TRANS/WP.29/GRE/2003/4
27 January 2003

World Forum for Harmonization of Vehicle Regulations (WP.29)

PROPOSAL FOR DRAFT AMENDMENTS (SUPPLEMENT 23 TO
THE 03 SERIES OF AMENDMENTS) TO REGULATION No.37
(Filament lamps)

Transmitted by the expert from the International Electrotechnical Commission (IEC)

Sheet R5W/1

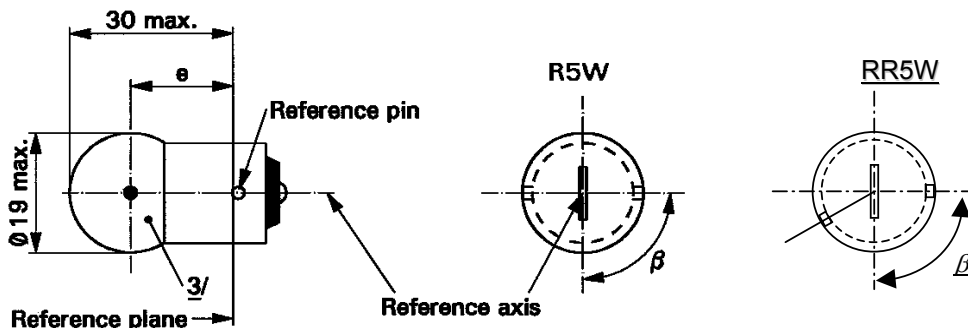
Sheet R5W, replace by the new sheet R5W and RR5W

Dimensions in mm	Filament lamps of normal production			Standard filament lamp	
	min.	nom.	max.	<u>4/</u>	
e	17.5	19.0	20.5	19.0 ± 0.3	
Lateral deviation <u>2/</u>			1.5	0.3 max.	
β	60°	90°	120°	90° ± 5°	
Cap: R5W: BA15s RR5W: BAW15s	in accordance with IEC Publication 60061			(sheet 7004-11A-9) <u>1/</u> (sheet 7004-...-1)	
ELECTRICAL AND PHOTOMETRIC CHARACTERISTICS					
Rated values	Volts	6 <u>5/</u>	12	24	12
	Watts	5			5
Test voltage	Volts	6.75	13.5	28.0	13.5
Objective values	Watts		5.5 max.	7.7 max.	5.5 max.
	Luminous flux	R5W	50 ± 20 %		
		RR5W	<u>5/</u>	12 ± 25 %	
Reference luminous flux at approximately 13.5 V:		White: 50 lm Red: 12 lm

- 1/ Filament lamps with cap BA15d may be used for special purposes; they have the same dimensions.
- 2/ Maximum lateral deviation of filament centre from two mutually perpendicular planes both containing the reference axis and one containing the axis of the reference pin.
- 3/ The light emitted from filament lamps of normal production shall be white for category R5W and red for category RR5W. (See also note 4/.)
- 4/ The light emitted from standard filament lamps shall be white for category R5W; white or red for category RR5W.
- 5/ Within RR5W no 6 V rated voltage type specified .

Sheet R10W/1

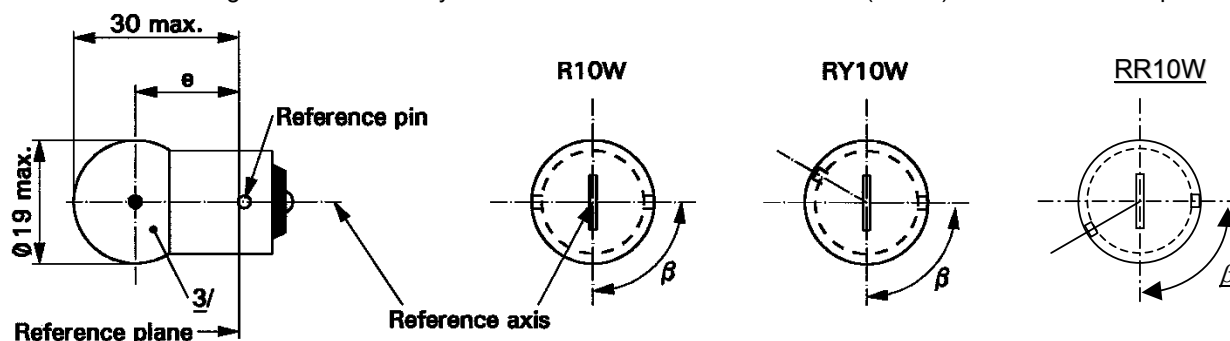
Sheet R10W and RY10W, replace by the new sheet R10W, RY10W and RR10W

Dimensions in mm		Filament lamps of normal production			Standard filament lamp	
		min.	nom.	max.	<u>4/</u>	
E		17.5	19.0	20.5	19.0 ± 0.3	
Lateral deviation	<u>2/</u>			1.5	0.3 max.	
β		60°	90°	120°	90° ± 5°	
R10W: BA15s Cap: RY10W: BAU15s RR10W: BAW15s					(sheet 7004-11A-9) <u>1/</u> (sheet 7004-19-1) (sheet 7004-...-1)	
ELECTRICAL AND PHOTOMETRIC CHARACTERISTICS						
Rated values		Volts	6 <u>5/</u>	12	24	12
		Watts	10			10
Test voltage		Volts	6.75	13.5	28	13.5
Objective values	Watts	R10W RY10W	11 max.		14 max.	11 max.
		RR10W	<u>5/</u>	11 max.		11 max.
	Luminous flux	R10W	125 ± 20 %			
		RY10W	75 ± 20 %			
RR10W		<u>5/</u>	30 ± 25 %			
Reference luminous flux at approximately 13.5 V:		White: 125 lm Amber: 75 lm Red: 30 lm

- 1/ Filament lamps R10W with cap BA15d may be used for special purposes; they have the same dimensions.
- 2/ Maximum lateral deviation of filament centre from two mutually perpendicular planes both containing the reference axis and one containing the axis of the reference pin.
- 3/ The light emitted from filament lamps of normal production shall be white for category R10W, amber for category RY10W and red for category RR10W. (See also note 4/.)
- 4/ The light emitted from standard filament lamps shall be white for category R10W; white or amber for category RY10W; white or red for category RR10W.
- 5/ Within RR10W no 6 V rated voltage type specified.

Sheet W5W/1

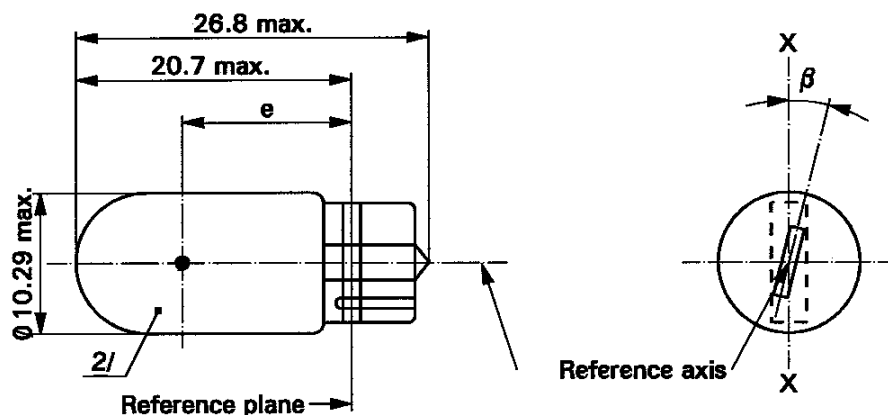
Sheet W5W and sheet WY5W, replace by the new sheet W5W, WY5W and WR5W

Dimensions in mm		Filament lamps of normal production			Standard filament lamp
		min.	nom.	max.	<u>3/</u>
E		11.2	12.7	14.2	12.7 ± 0.3
Lateral deviation	<u>1/</u>			1.5	0.5 max.
β		- 15°	0°	+ 15°	0° ± 5°
Cap W2.1x9.5d in accordance with IEC Publication 60061 (sheet 7004-91-3)					
ELECTRICAL AND PHOTOMETRIC CHARACTERISTICS					
Rated values	Volts	6 <u>4/</u>	12	24	12
	Watts	5			5
Test voltage	Volts	6.75	13.5	28.0	13.5
Objective values	Watts	5.5 max.		7.7 max.	5.5 max.
	Luminous flux	W5W	50 ± 20 %		
		WY5W	30 ± 20 %		
		WR5W	<u>4/</u>	12 ± 25 %	
Reference luminous flux At approximately 13.5 V:		White: 50 lm Amber: 30 lm Red: 12 lm

- 1/ Maximum lateral deviation of filament centre from two mutually perpendicular planes both containing the reference axis and one containing axis X-X.
- 2/ The light emitted from filament lamps of normal production shall be white for category W5W, amber for category WY5W and red for category WR5W. (See also note 3/.)
- 3/ The light emitted from standard filament lamps shall be white for category W5W; white or amber for category WY5W; white or red for category WR5W.
- 4/ Within WR5W no 6 V rated voltage type specified .

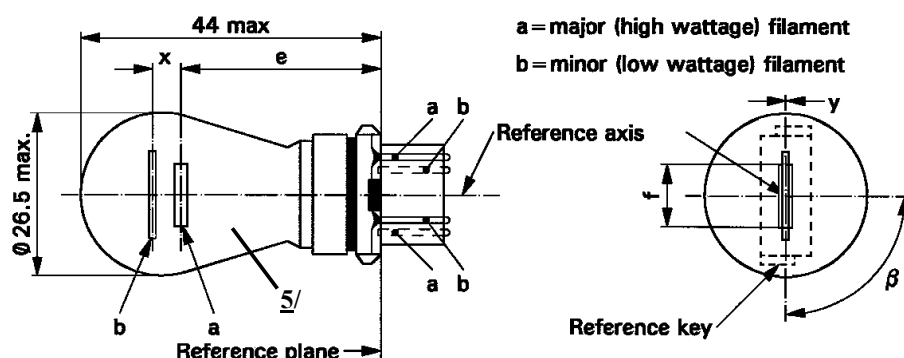
Sheets PY27/7W, replace by new sheet PY27/7W

Dimensions in mm	Filament lamps of normal production			Standard filament lamp	
	min.	nom.	max.	6/	
E		27.9 3/		27.9 ± 0.3	
F			9.9	9.9 + 0/ - 2	
Lateral deviation 2/			3/	0.0 ± 0.4	
x 4/		5.1 3/		5.1 ± 0.5	
y 4/		0.0 3/		0.0 ± 0.5	
β	75° 3/	90°	105° 3/	90° ± 5°	
Cap WX2.5x16q in accordance with IEC Publication 60061 (sheet 7004-104A-1)					
ELECTRICAL AND PHOTOMETRIC CHARACTERISTICS					
Rated values	Volts	12		12	
	Watts	27	7	27	7
Test voltage	Volts	13.5		13.5	
Objective values	Watts	32.1 max.	8.5 max.	32.1 max.	8.5 max.
	Luminous flux	280 ± 15 %	21 ± 15 %		
Reference luminous flux at approximately 13.5 V:	White: 475 and 36 lm Amber: 280 and 21 lm

5/ The light emitted from filament lamps of normal production shall be amber. (See also note 6/)

6/ The light emitted from standard filament lamps shall be amber or white.

CATEGORIES P19W, PY19W, PR19W, PS19W, PSY19W AND PSR19W**Sheet P19W/2**

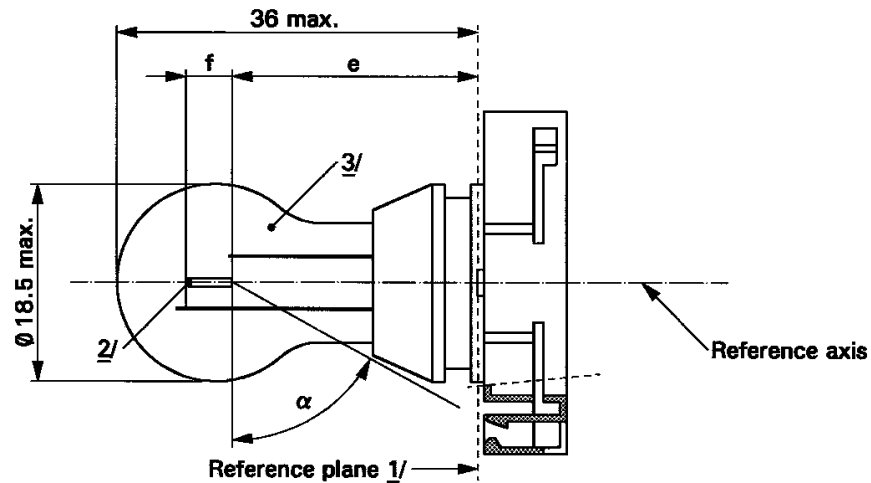
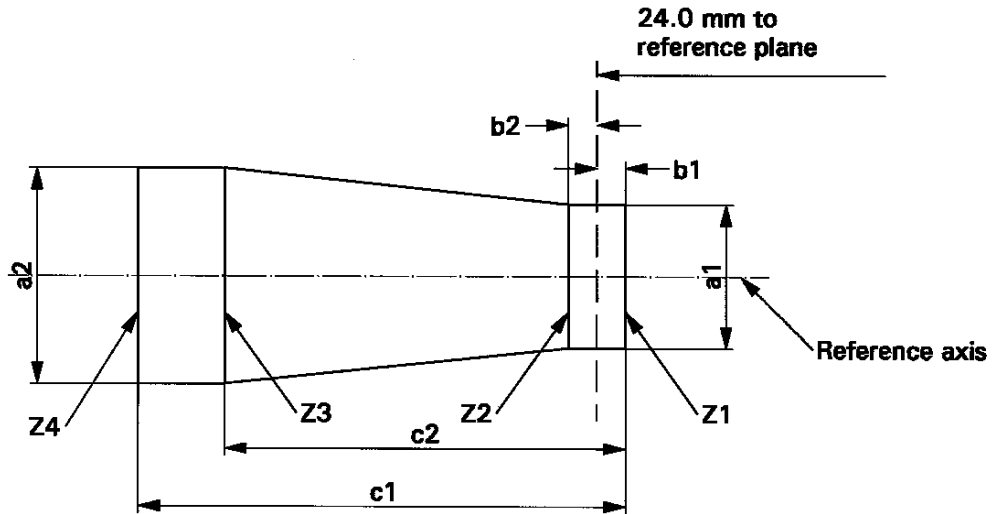
Sheets P19W, PS19W, PY19W and PSY19W, replace by the new sheets P19W, PY19W, PR19W, PS19W, PSY19W, PSR19W

- 1/ The reference plane is defined by the meeting points of the cap-holder fit.
- 2/ No actual filament diameter restrictions apply but the objective is d max. = 1.1 mm.
- 3/ The light emitted from normal production lamps shall be white for categories P19W and PS19W; amber for categories PY19W and PSY19W; red for categories PR 19W and PSR 19W.
(See also note 8/)

Dimensions in mm	<u>4/</u>	Filament lamps of normal production			Standard filament lamp
		min.	nom.	max.	<u>8/</u>
e	<u>5/</u> <u>6/</u>		24.0		24.0
f	<u>5/</u> <u>6/</u>		4.0		4.0 ± 0.2
α	<u>7/</u>	61.5°			61.5° min.
P19W Cap PGU20-1 PY19W Cap PGU20-2 PR19W Cap PGU20-5 PS19W Cap PG20-1 PSY19W Cap PG20-2 PSR19W Cap PG20-5		in accordance with IEC Publication 60061 (sheet 7004-127-1)			
ELECTRICAL AND PHOTOMETRIC CHARACTERISTICS					
Rated values	Volts	12			12
	Watts	19			19
Test voltage	Volts	13.5			13.5
Objective values	Watts	20 max.			20 max.
	Luminous flux	P19W PS19W	350 ± 15 %		
		PY19W PSY19W	215 ± 20 %		
		PR19W PSR19W	80 ± 20 %		
Reference luminous flux at approximately 13.5 V		White: 350 lm Amber: 215 lm Red: 80 lm

8/ The light emitted from standard filament lamps shall be white for categories P19W and PS19W; white or amber for categories PY19W and PSY19W; white or red for categories PR19W and PSR19W.

CATEGORIES P24W, PY24W, PR24W, PS24W, PSY24W AND PSR24W**Sheet P24W/1**

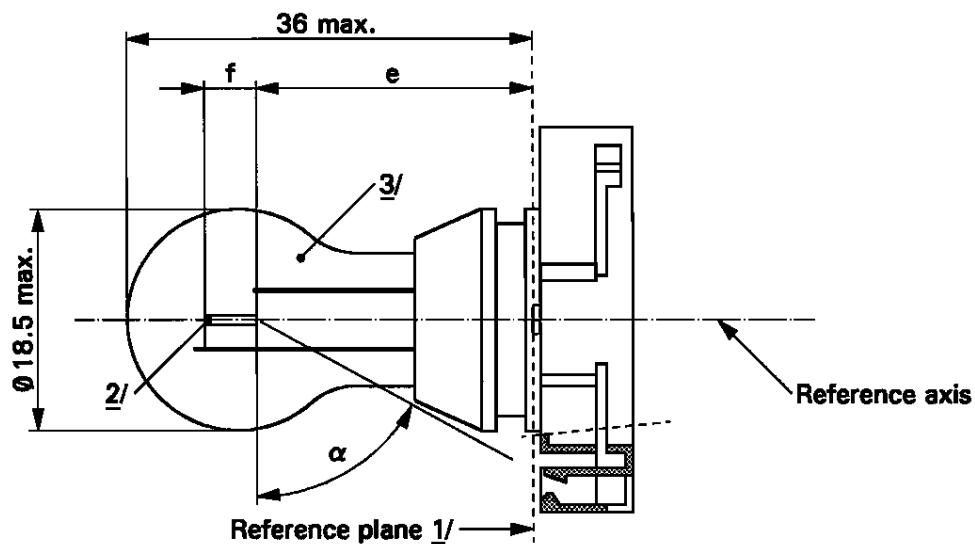
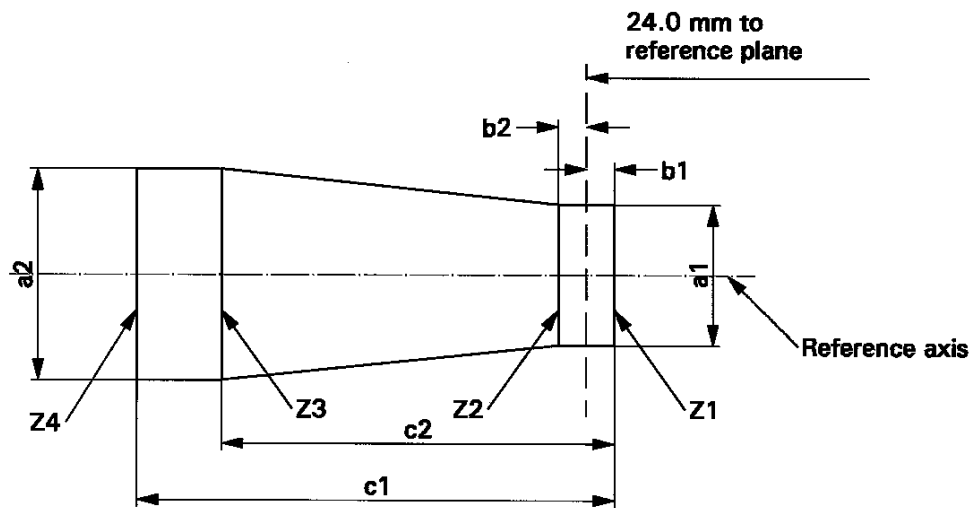
Sheets P24W, PS24W, PY24W and PSY24W, replace by the new sheets P24W, PY24W, PR24W, PS24W, PSY24W, PSR24W

3/ The light emitted from normal production lamps shall be white for categories P24W and PS24W; amber for categories PY24W and PSY24W; red for the categories PR24W and PSR24W.
(See also note 8/)

Dimensions in mm	<u>4/</u>	Filament lamps of normal production			Standard filament lamp
		min.	nom.	max.	<u>8/</u>
e	<u>5/</u> <u>6/</u>		24.0		24.0
f	<u>5/</u> <u>6/</u>		4.0		4.0 ± 0.2
α	<u>7/</u>	61.5°			61.5° min.
P24W Cap PGU20-3 PY24W Cap PGU20-4 PR24W Cap PGU20-6 PS24W Cap PG20-3 PSY24W Cap PG20-4 PSR24W Cap PG20-6		in accordance with IEC Publication 60061 (sheet 7004-127-1)			
ELECTRICAL AND PHOTOMETRIC CHARACTERISTICS					
Rated values	Volts	12			12
	Watts	24			24
Test voltage	Volts	13.5			13.5
Objective values	Watts	25 max.			25 max.
	Luminous flux	P24W PS24W	500 +10/-20 %		
		PY24W PSY24W	300 +15/-25 %		
		PR24W PSR24W	115 +15/-25 %		
Reference luminous flux at approximately 13.5 V		White: 500 lm Amber: 300 lm Red: 115 lm

- 4/ For categories PS24W, PSY24W and PSR24W, dimensions shall be checked with O-ring removed.
- 5/ The filament position is checked by means of a "box-system"; sheet P24W/3.
- 6/ The ends of the filament are defined as the points where, when the viewing direction is perpendicular to the plane through the filament lead-in wires as showed in the drawing on sheet P24W/1, the projection of the outside of the end turns crosses the filament axis.
- 7/ No part of the cap beyond the reference plane shall interfere with angle α. The bulb shall be optically distortion free within the angle 2α + 180°.
- 8/ The light emitted from standard filament lamps shall be white for categories P24W and PS24W; white or amber for categories PY24W and PSY24W; white or red for categories PR24W and PSR24W.

Sheet PR21W/1

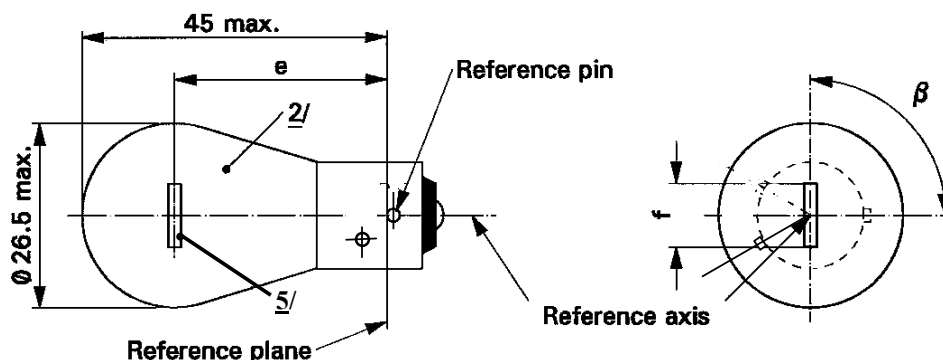
Add at the end new data sheets PR21W, PR21/4W, PR21/5W, PR27/7W, to read:

Dimensions in mm		Filament lamps of normal production			Standard filament lamp
		min.	nom.	max.	<u>4/</u>
E	12 V		31.8 <u>3/</u>		31.8 ± 0.3
	24 V	30.8	31.8	32.8	
F	12 V	5.5	6.0	7.0	6.0 ± 0.5
Lateral <u>1/</u> deviation	12 V			<u>3/</u>	0.3 max
	24 V			1.5	
β		75°	90°	105°	$90^\circ \pm 5^\circ$
Cap BAW15s in accordance with IEC Publication 60061 (sheet 7004-...-1)					
ELECTRICAL AND PHOTOMETRIC CHARACTERISTICS					
Rated values	Volts	12	24	12	
	Watts	21			21
Test voltage	Volts	13.5	28.0		
Objective values	Watts	26.5 max.	29.7 max.	26.5 max.	
	Luminous flux	$110 \pm 20 \%$			
Reference luminous flux at approximately 13.5 V:		White:	460 lm		
		Red:	110 lm

- 1/ Maximum lateral deviation of filament centre from two mutually perpendicular planes both containing the reference axis and one containing the axis of the reference pin.
- 2/ The light emitted from normal production lamps shall be red (See also note 4/).
- 3/ To be checked by means of a "box system", sheet P21W/2.
- 4/ The light emitted from standard filament lamps shall be white or red.
- 5/ In this view the filament of the 24 V type may be straight or V-shaped. This shall be indicated in the application of approval. If it is straight, the screen projection requirements, sheet P21W/2, apply. If it is V-shaped, the filament ends shall be at the same distance within ± 3 mm from the reference plane.
